DE'LONGHI "NZ/AU" ESAM5450

INFORMAZIONE TECNICA / TECHNICAL INFORMATION

MODELLI / MODELS : ESAM tutti i modelli / ESAM all models

OGGETTO: Nuovo telaio + nuovo contenitore fondi
SUBJECT : New chassis + new grounds container

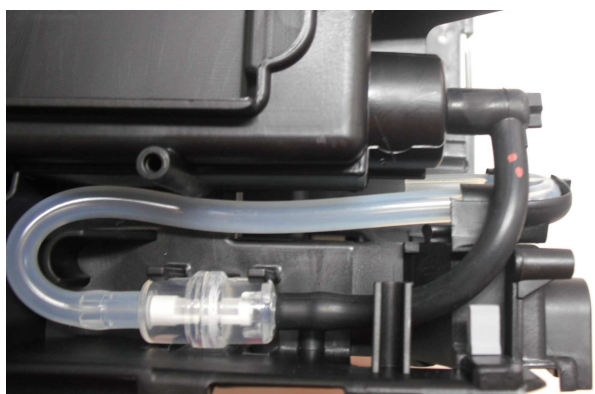
Please be informed that, starting **from January 2011** and then progressively on all model/versions of ESAM, we have modified the chassis.

The new chassis, p/n **5513216731** is not singularly interchangeable with the previous one with p/n 5513212981, because it fits a new modification for the water tank valve opening as well as a new coffee grounds container.

If it is not, you will have to order the new chassis, **5513216731**
+ silicon white ring code **5313229141**
+ 90° black tube to connect the exit of the water tank, **5313218961**
+ new grounds container **5313228721**

Old chassis p/n 5513212981

Old coffee ground container p/n 5332274500

Chassis with new modification p/n 5513216731

Ring p/n 5313229141

New coffee ground cont. p/n 5313228721
